Agenda Item #1

Application 2026-14-CA

555 Government Street

Alterations to existing fenestration, construction of new galleries, and stucco brick on the existing lobby addition on north facade

Sheet Title:
 PROPOSED EXTERIOR ELEVATIONS

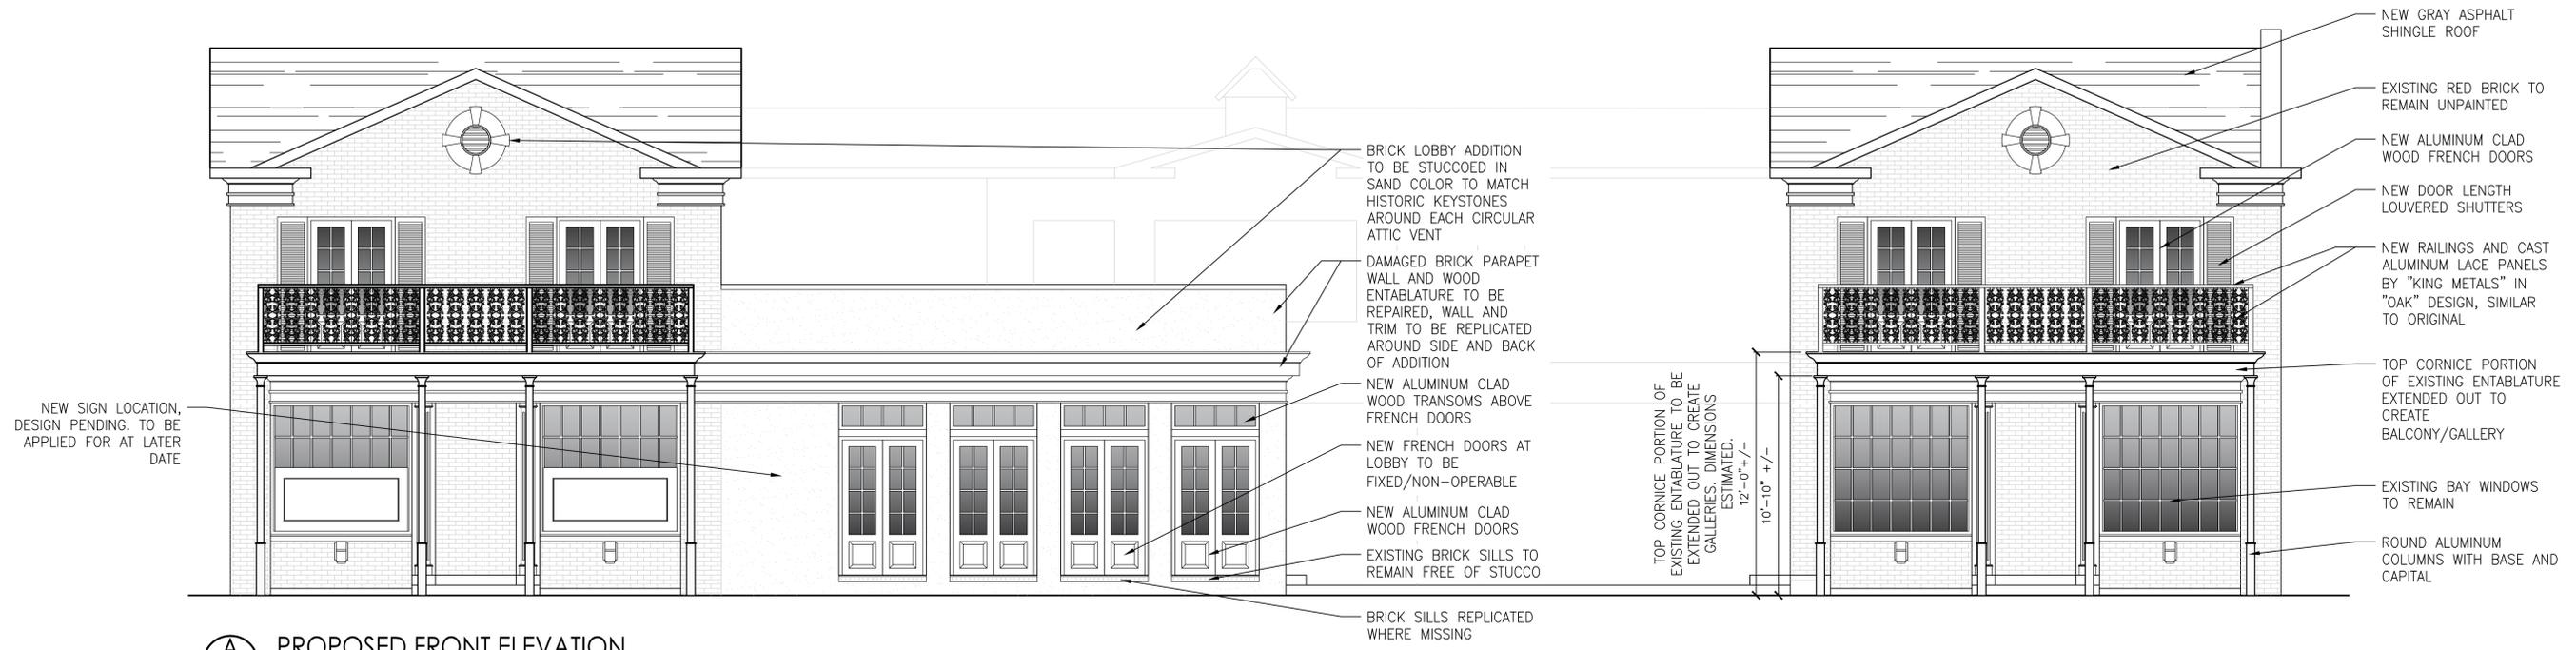
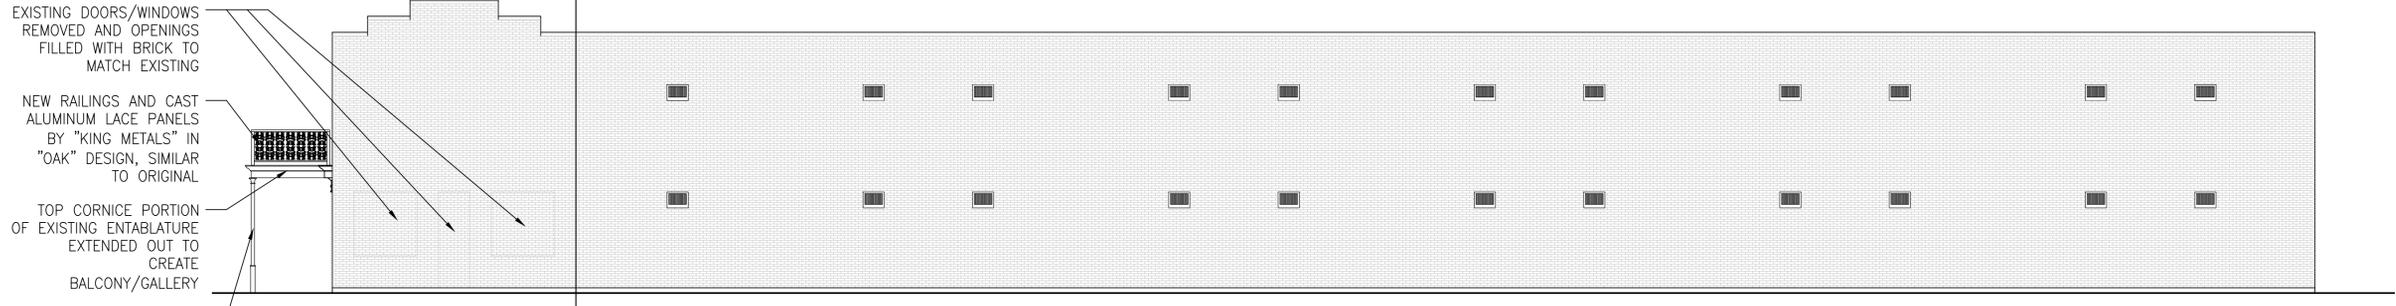
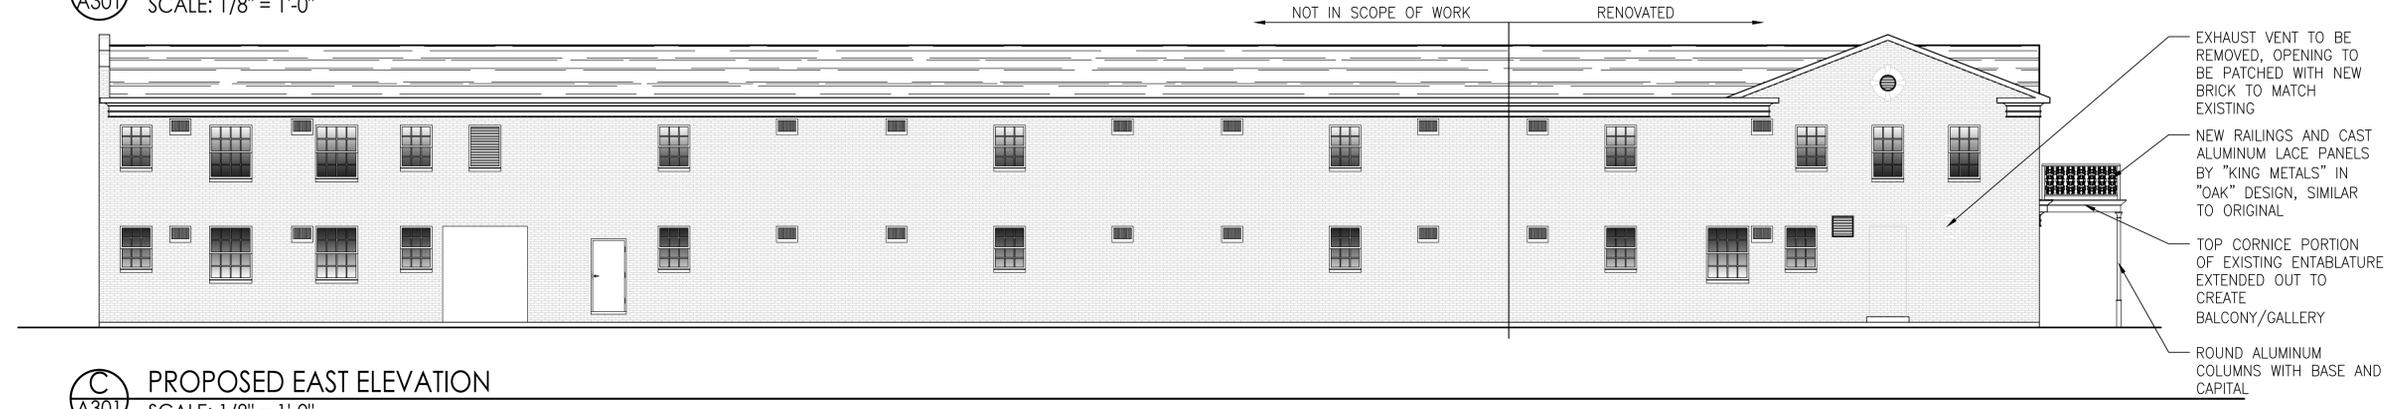
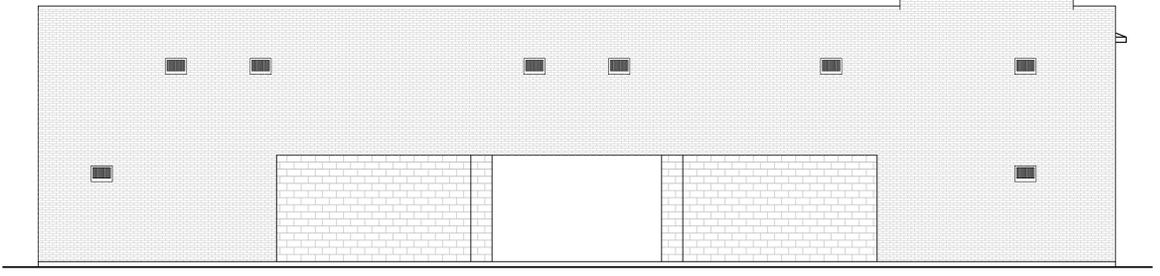
The first of the *Design Guidelines* instruct that the primary goal of any building treatment should be to “maintain the original orientation of a building to the street and neighborhood.” The application proposes removing the one remaining door on the north facade of the one-story wing as well as framing around the infilled entryways on the two gabled blocks. The remaining door would be replaced with 4 aluminum-clad French doors, 3 of which are inoperable. The French door on the west end of the lobby wing would have the left door fixed and the right door operable, allowing access to Government Street (7.31). Moreover, the *Guidelines* dictate that the “the decorative and functional features of a primary door” should be preserved. There will be 4 French doors on the north façade and from the plans submitted there is no indication which door is the primary door. It should be noted that the primary doors on the gabled blocks have not been present for a significant amount of time.

The *Guidelines* allow for adding galleries and balconies to existing buildings as long as they reflect the design of the original building and retain visibility of the cornice from the public right-of-way (7.14, 7.15) The proposed galleries would retain visibility of the cornice and would replicate the existing entablature to maintain the original appearance across the north façade of the gabled blocks. The simple design of the proposed gallery columns is traditional enough to blend with the Colonial Revival details of the property. The proposed balcony railings would imitate the decorative iron galleries that overlook the central motor court.

framing, and light configuration (5.20, 5.21). The application proposes removing all existing windows on the lobby wing and the second floor of the gabled block's north façade. The proposed French doors would imitate the existing wood paneling design on the first-floor windows of the north façade. The application also proposes removing two original windows from the west elevation and infilling the openings with brick. This minor alteration would be less disruptive to the image of the building, as it is located on a secondary elevation. However, this portion of the west elevation is still easily visible from Government Street.

The application of true stucco on the lobby wing addition that was constructed sometime between 1979 and 1993 would be appropriate with the *Guidelines* and would be reflective of some of the surrounding historic buildings (7.8). This existing addition sustained significant damage to the parapet wall which would require brick replacement and repair.
